Addendum No.: 4

Date of Addendum: May 4, 2020

Prudence Crandall Museum Renovations  
1 South Canterbury Road  
Canterbury, CT  
BI – RR – 28

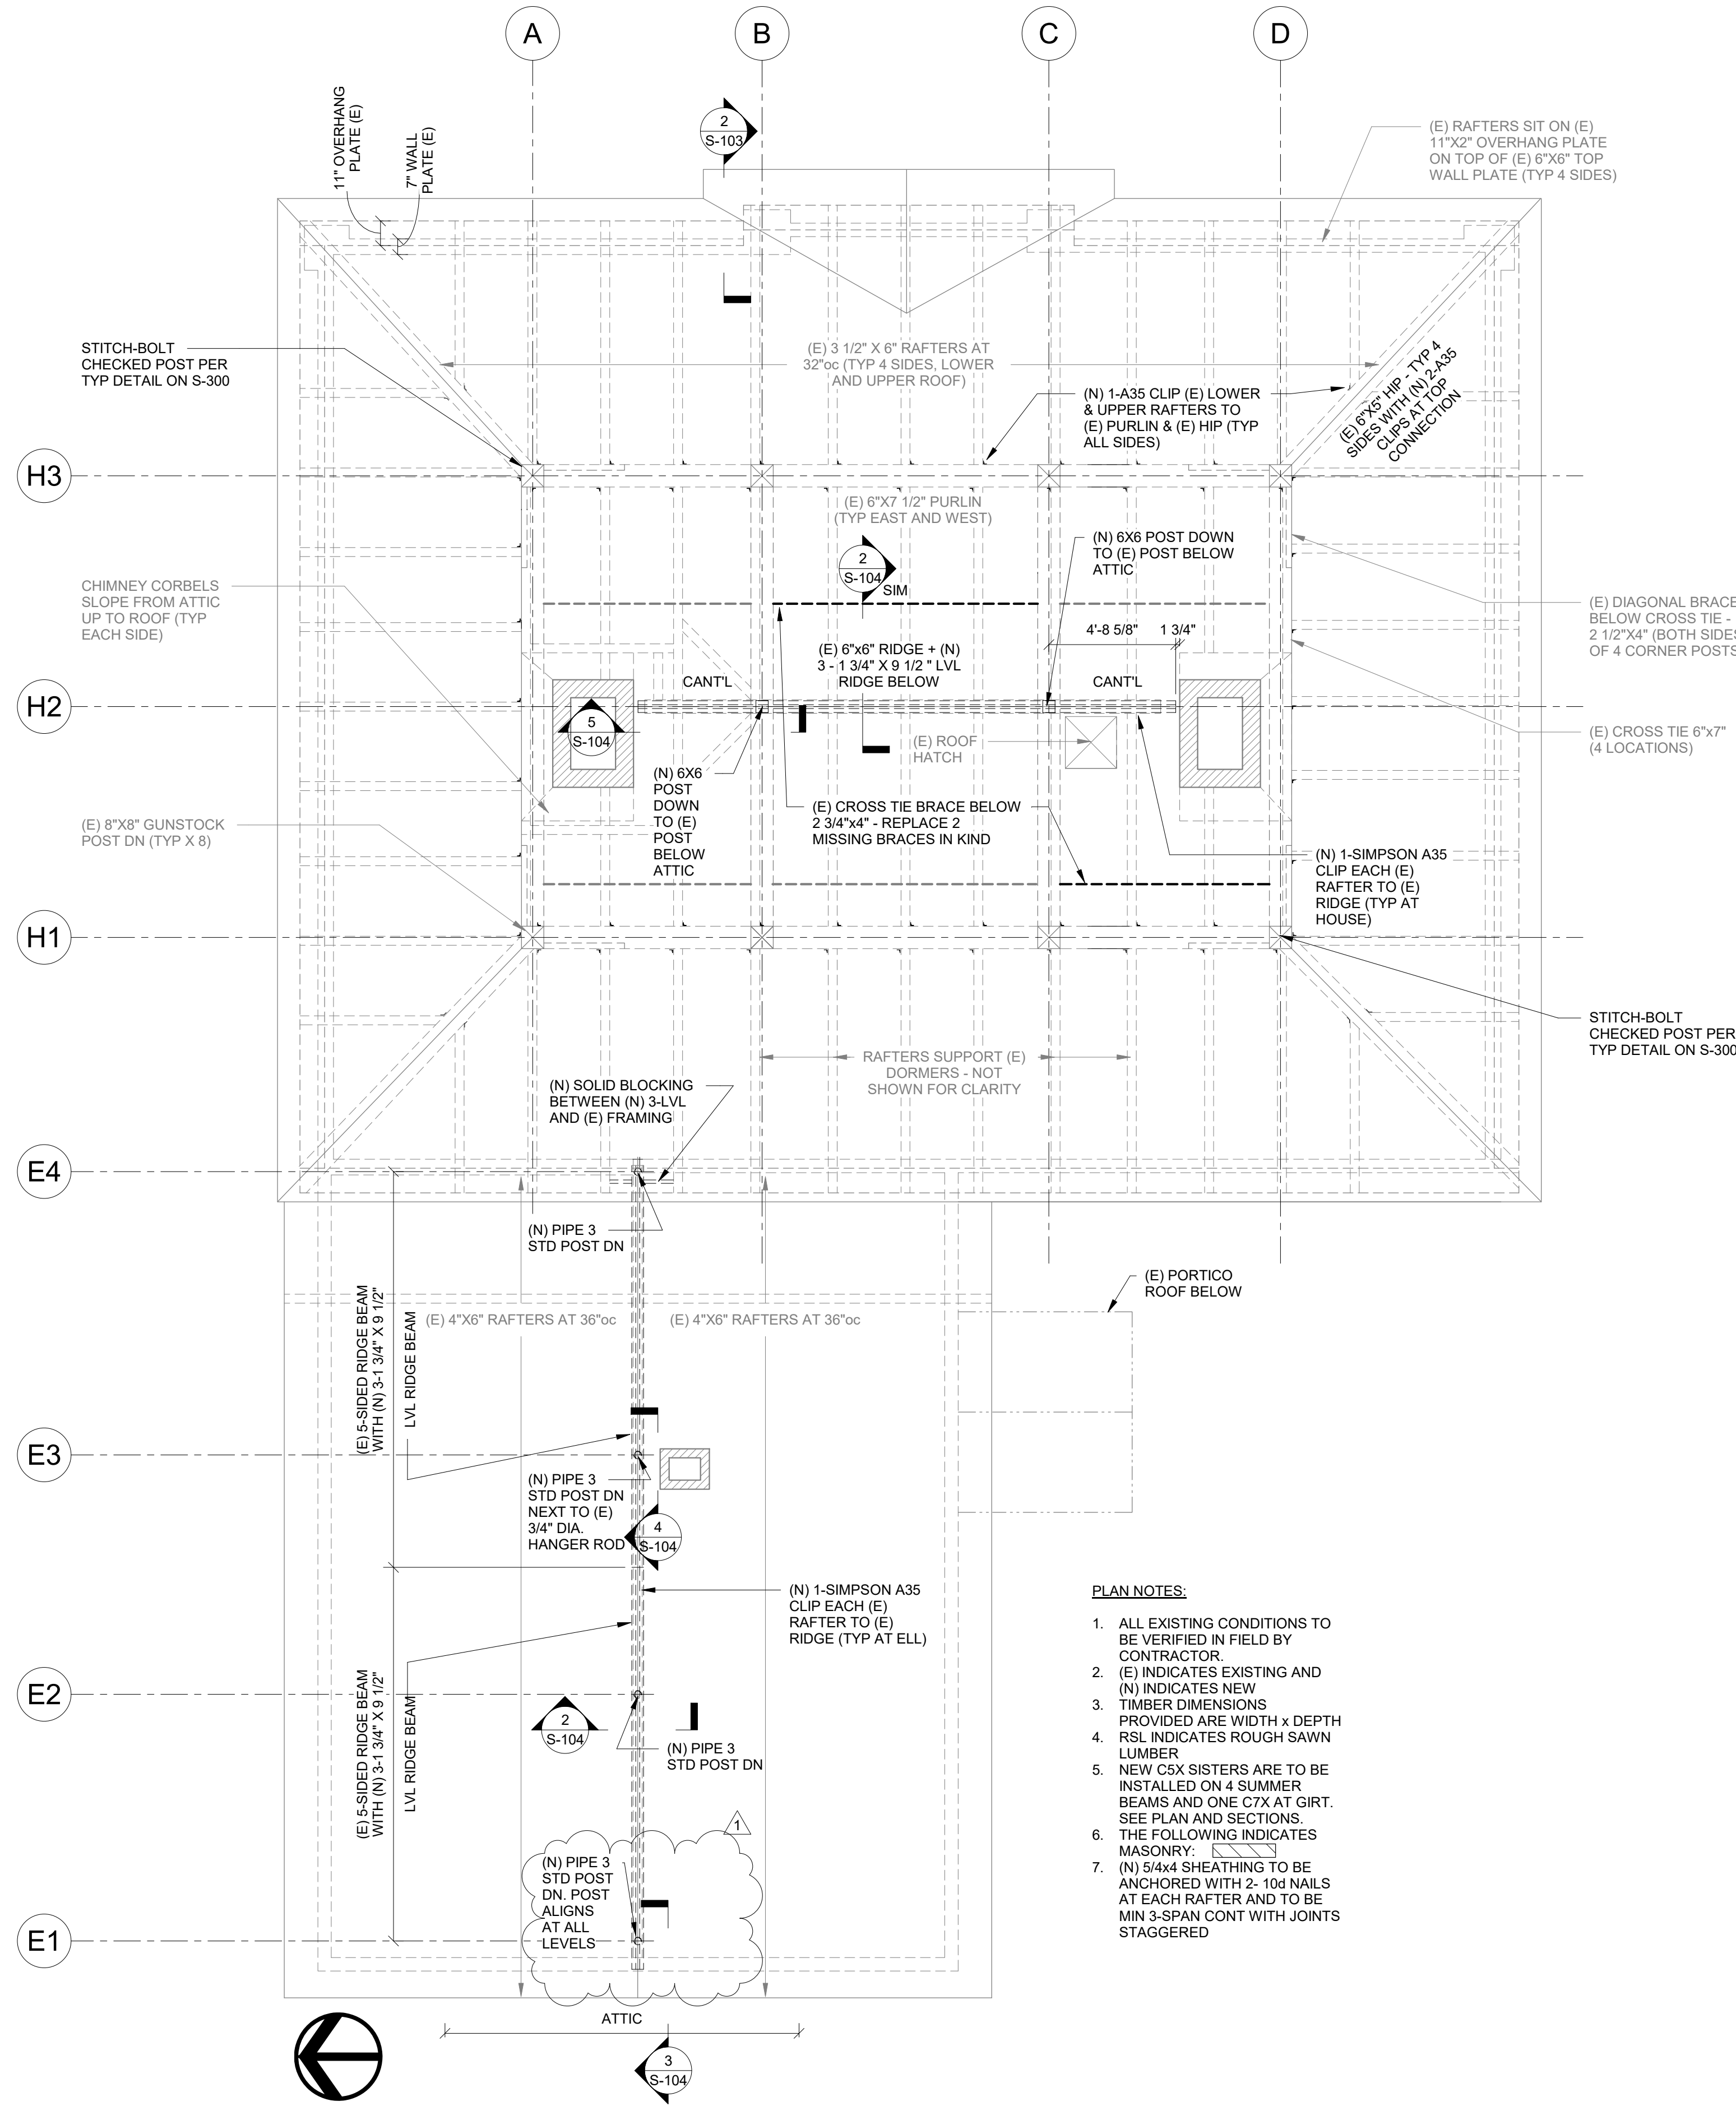
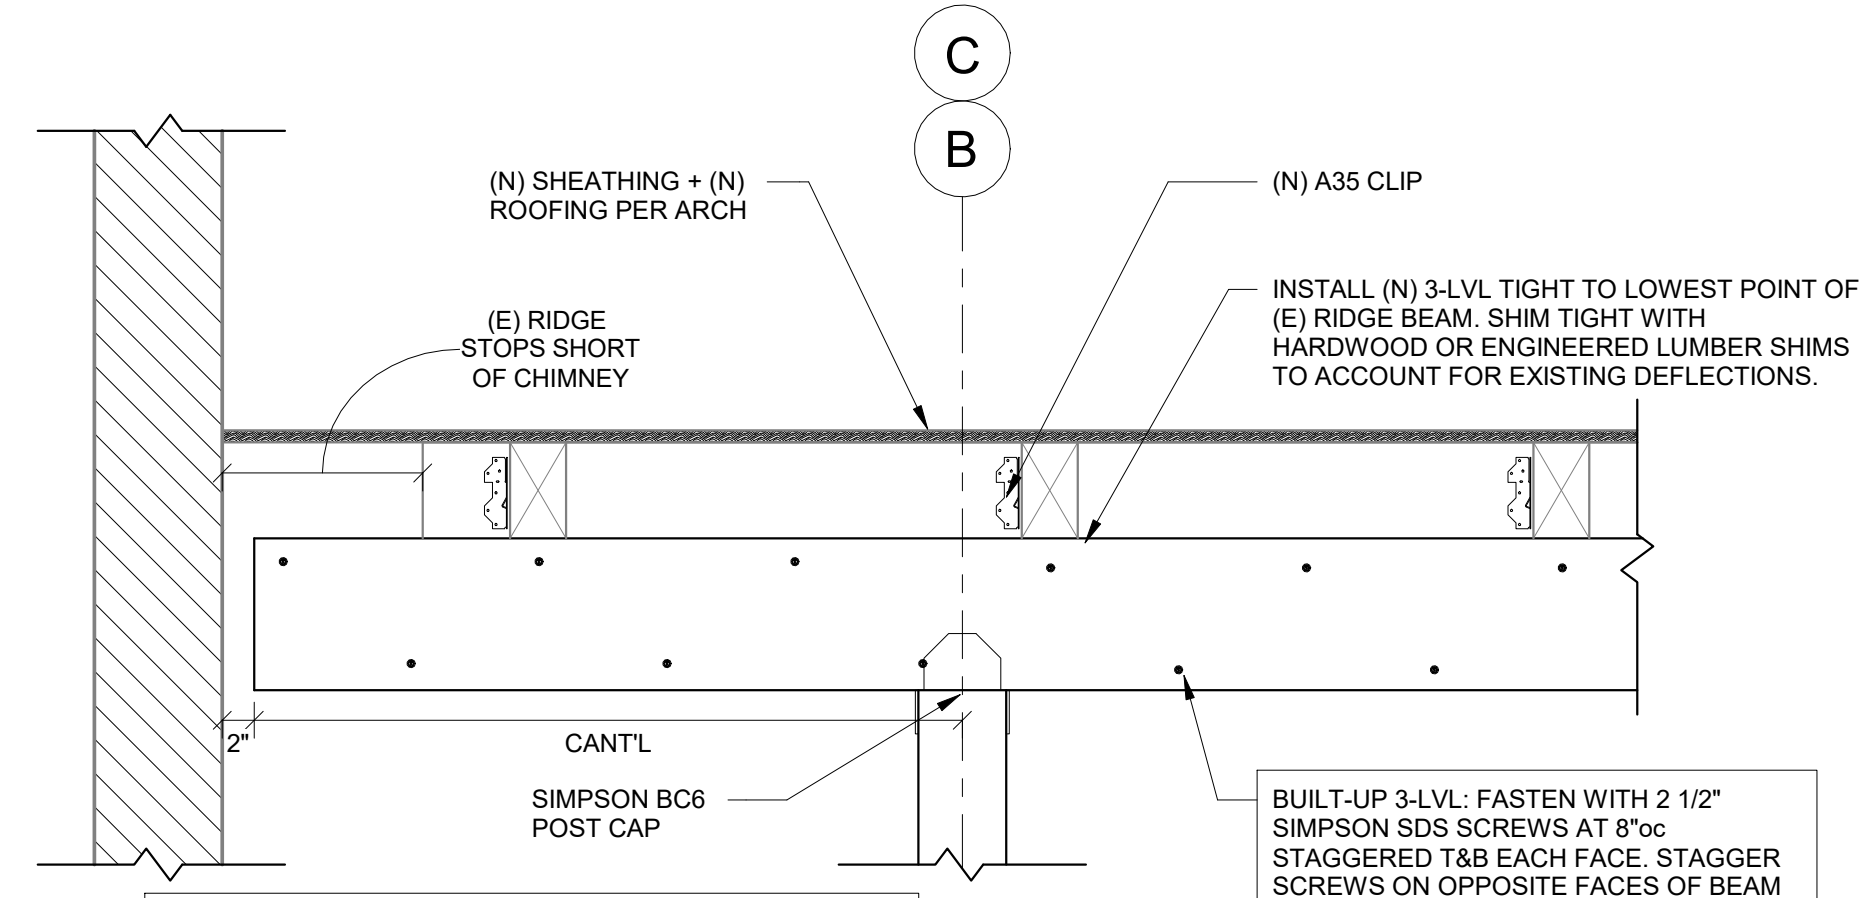
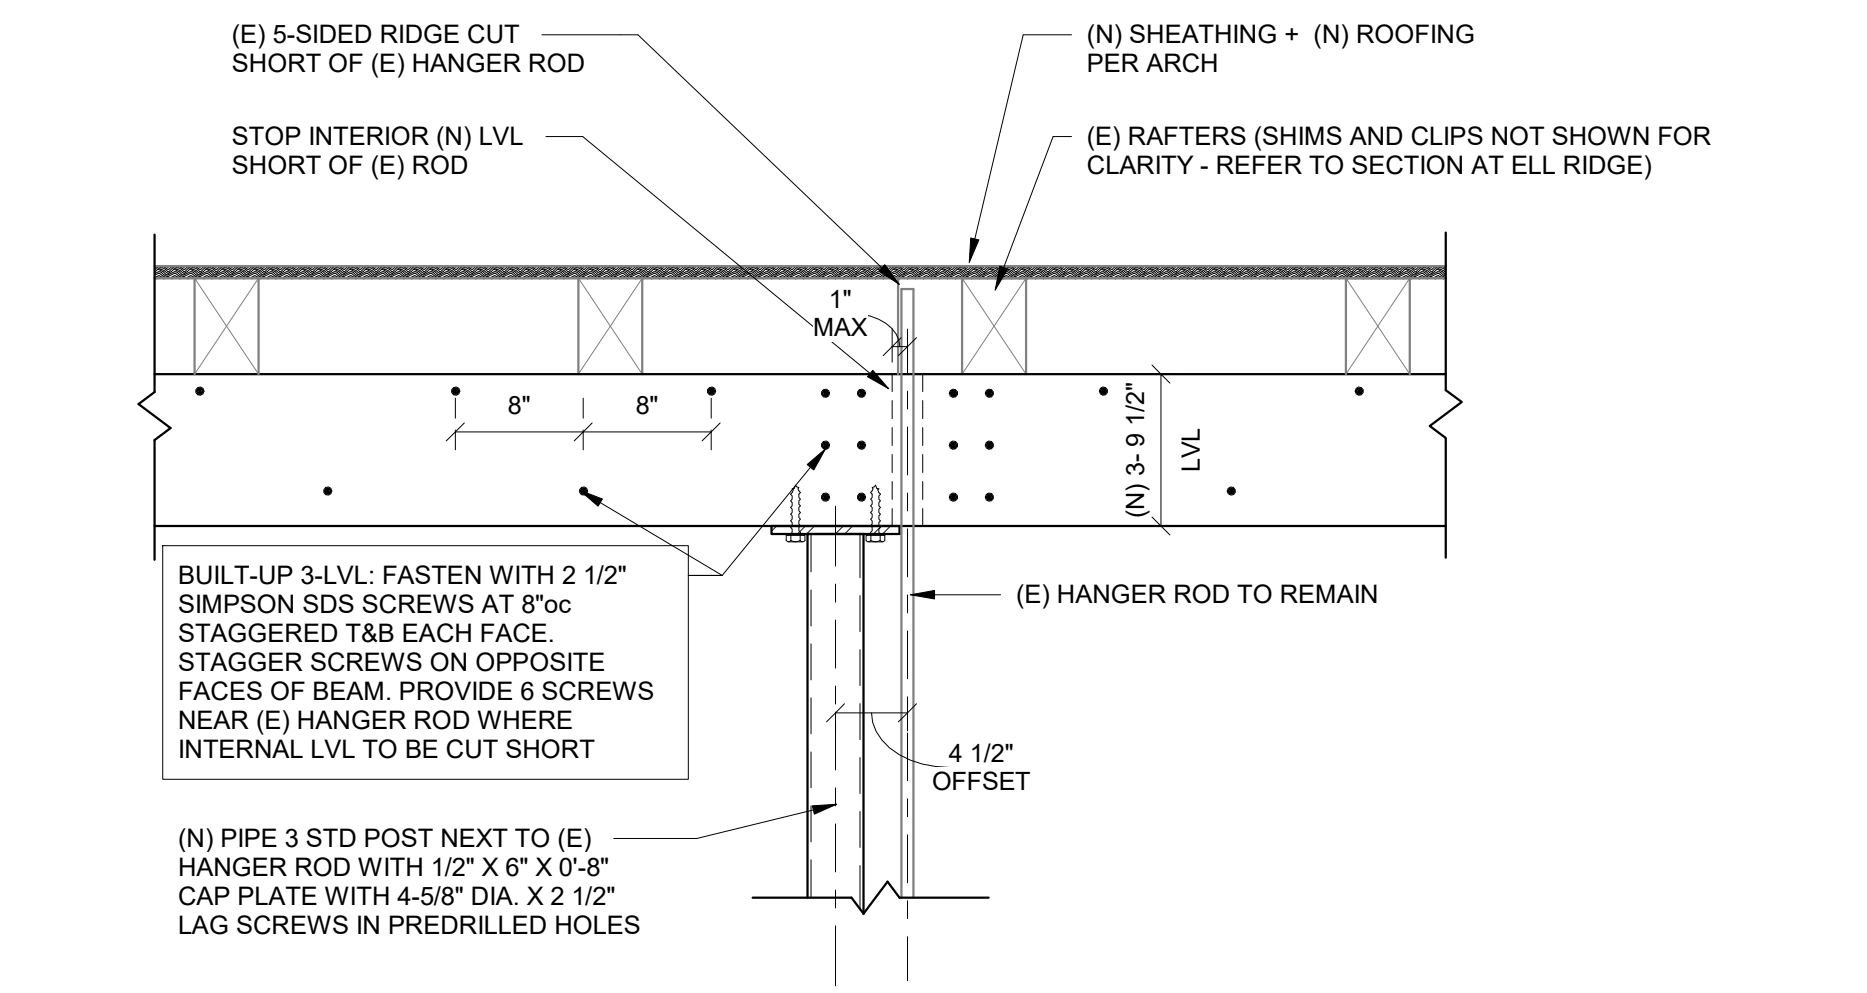
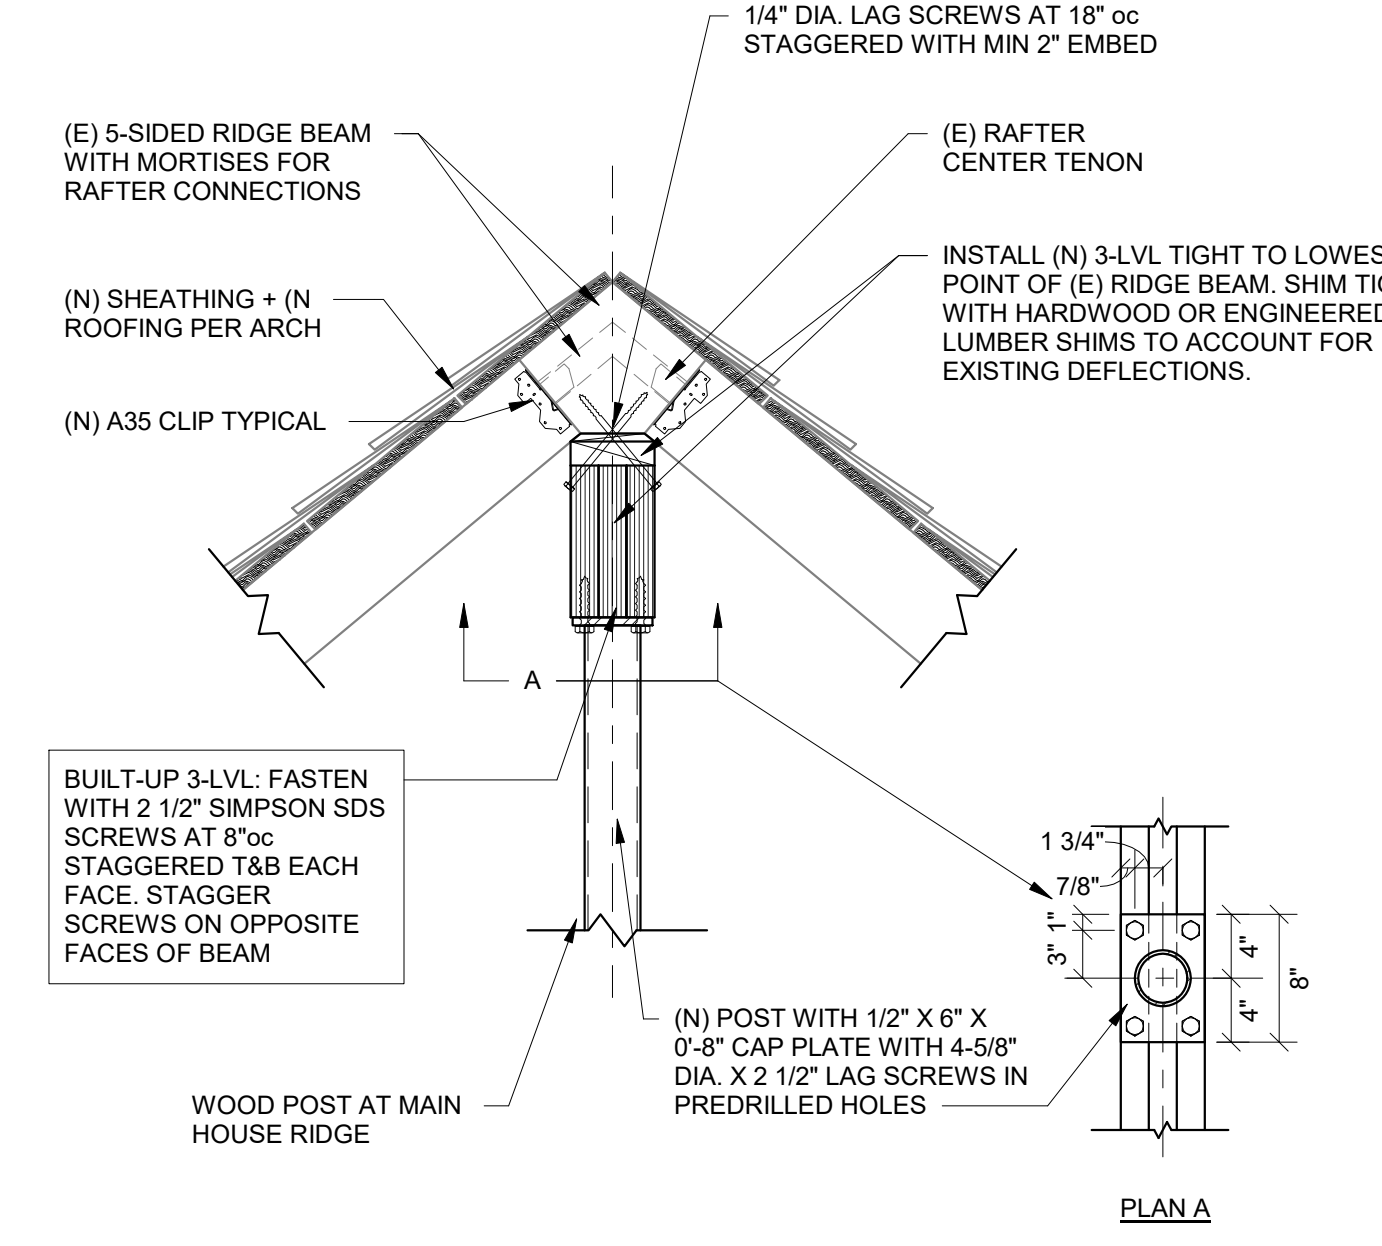
**Question 3:** *Drawing S-102 calls for a 3" pipe down at gridline E1. Drawing S-101 does not show a 3" pipe at E1. Drawing S-103 shows a representation of a pipe at E-1 with no call out. Please clarify if this pipe goes up or down, or both, or none?*

**RESPONSE:** Column should extend from ridge down to foundation. See revised structural drawings S-100, S-101, S-102, S-103, S-104, dated April 30, 2020, attached.
